Northern Pacific Railway Company.
Engineering Department Records.

TALAMANCA TENINO

Concrete plant

DRIVING CAP

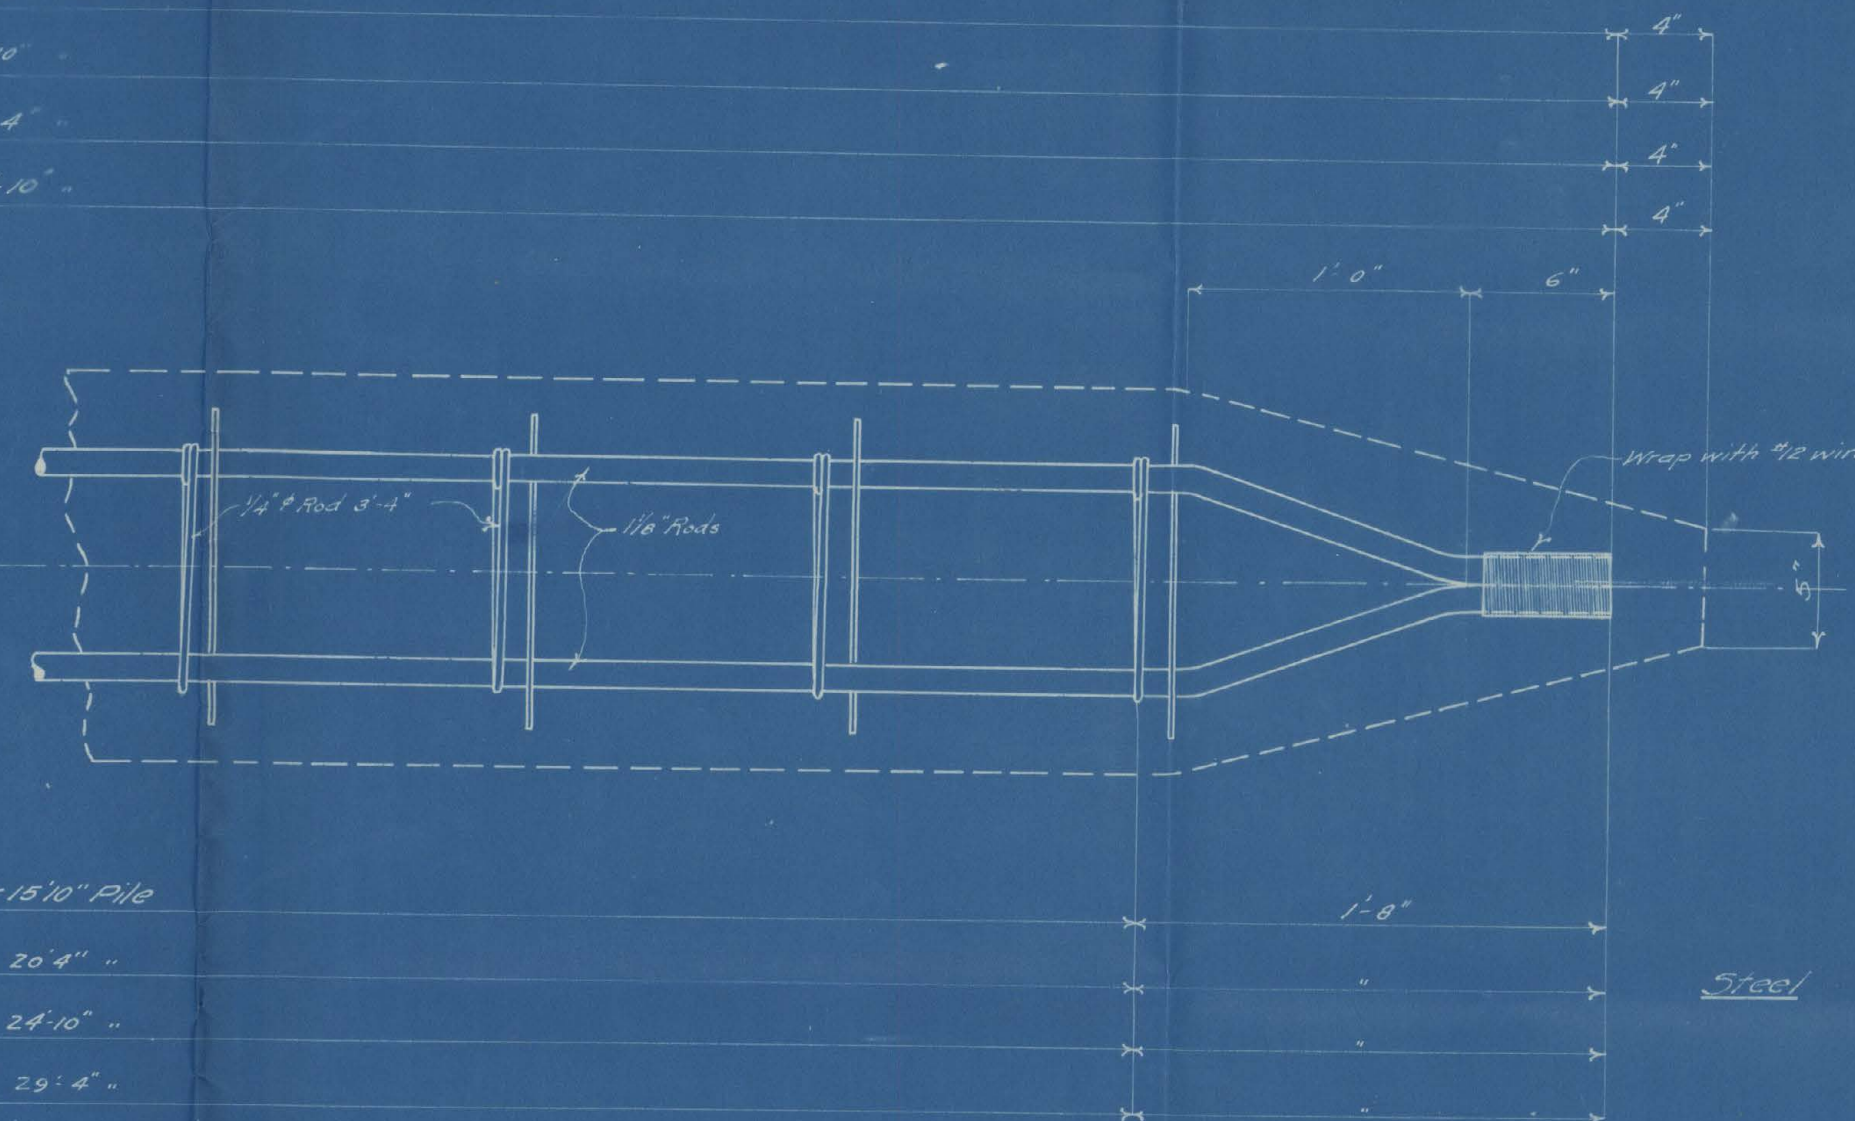
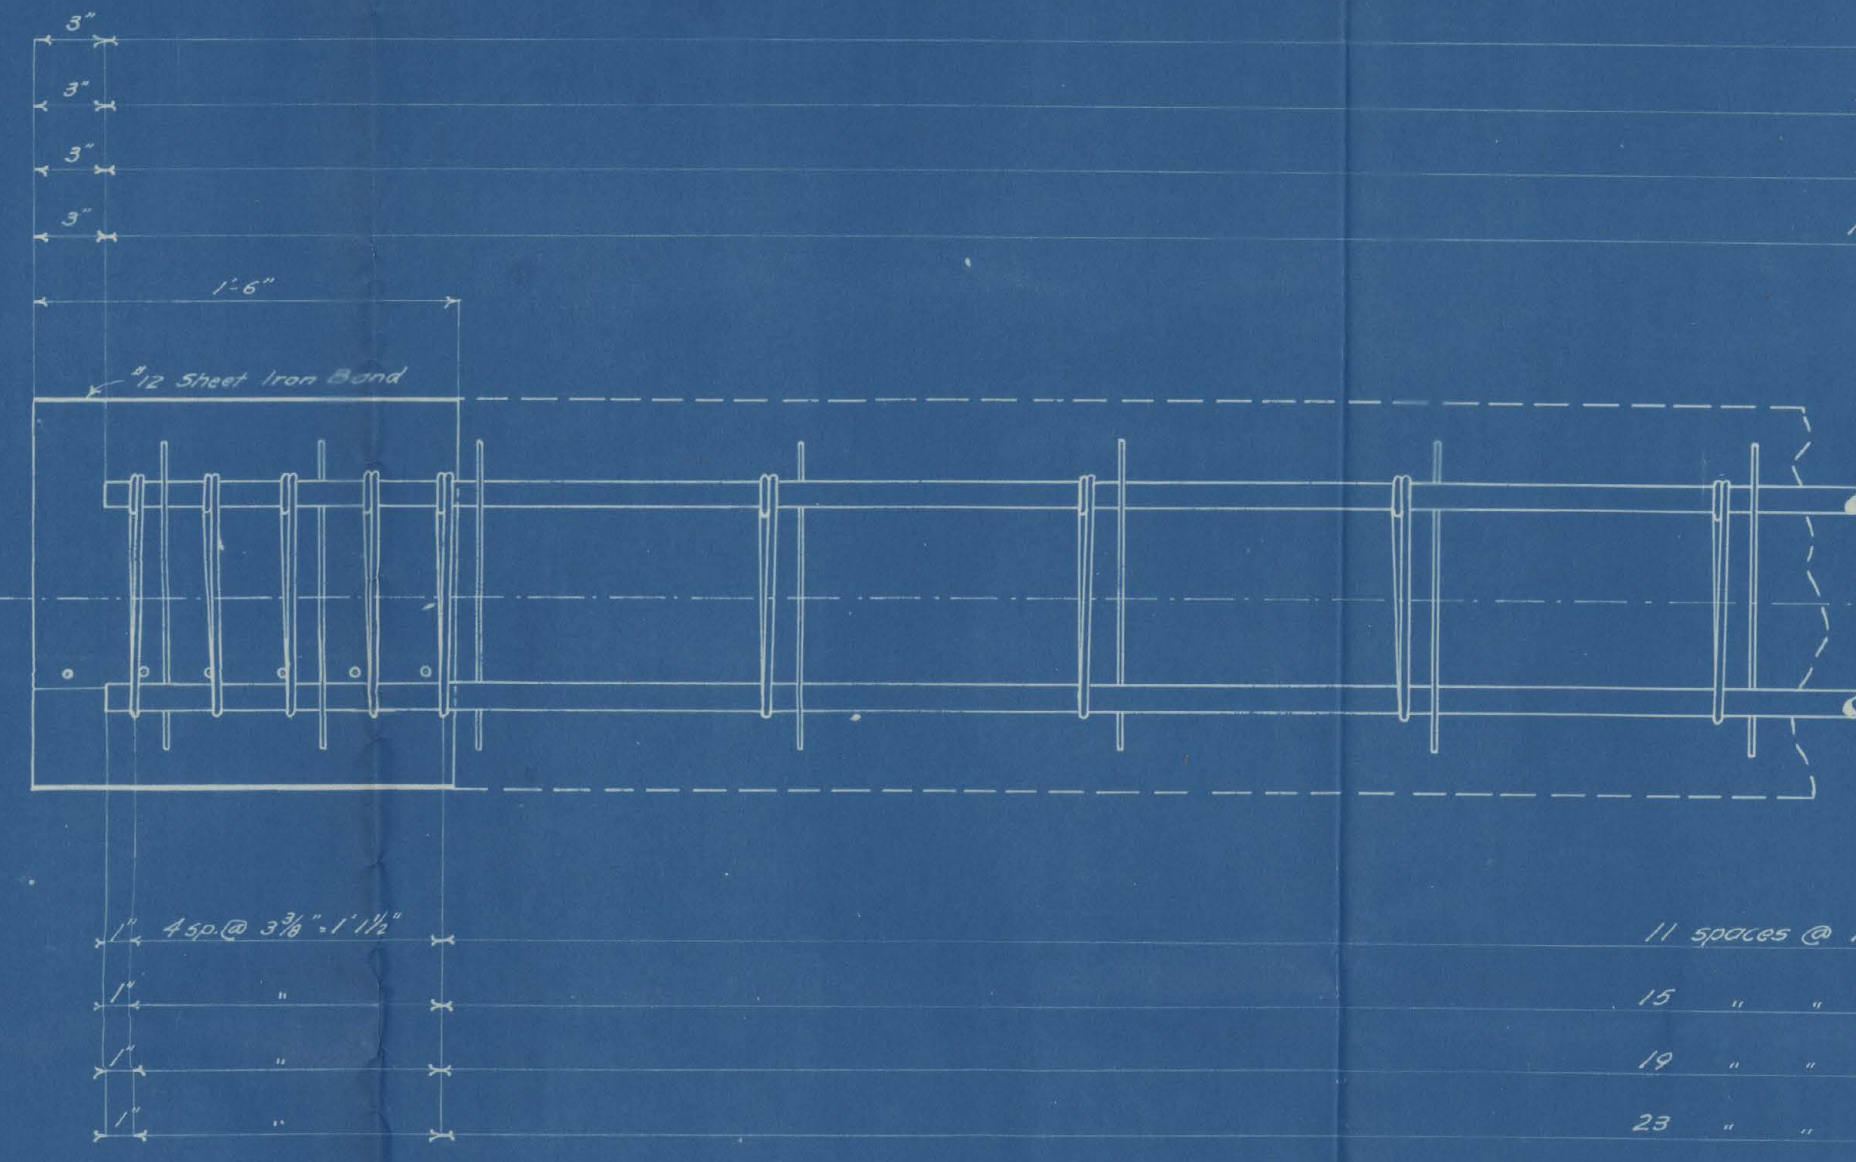
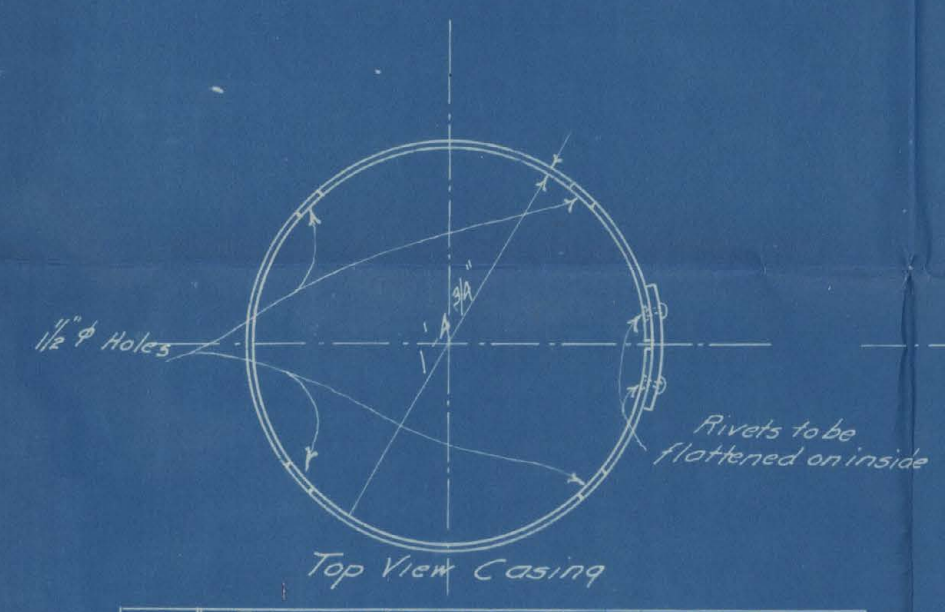
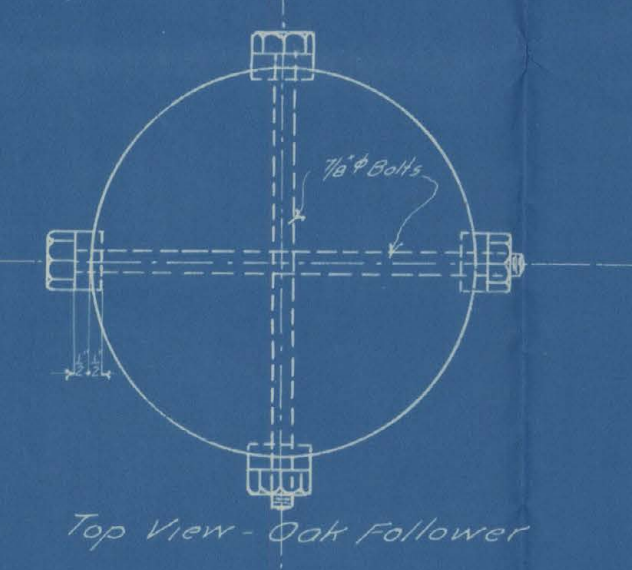
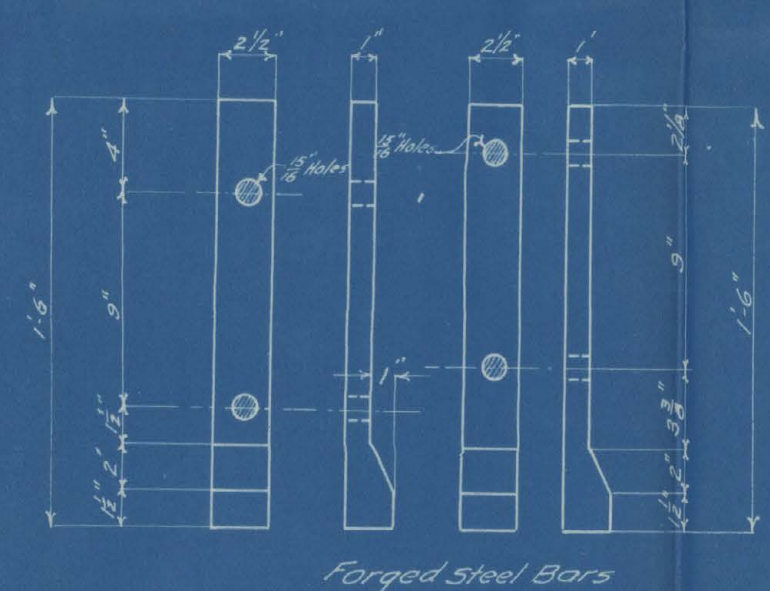
Mr. Bell advises me that the piles built at Auburn were not constructed as shown on this plan. The flat spacing bars were staggered, being placed alternately on vertical and horizontal bars; the bars were then revolved 45 degrees so that a clear opening is left at the top of the form for pouring concrete. This opening being only four inches in width in the round form makes it quite essential that the bars be so placed in order to get room for pouring the concrete.

For the round form this system of putting reinforcing is better than the one shown, and is no doubt the system that is still being followed at Auburn. Will you therefore kindly revise the plan to show the work as actually being done. One of your prints with these changes indicated, is returned you herewith.
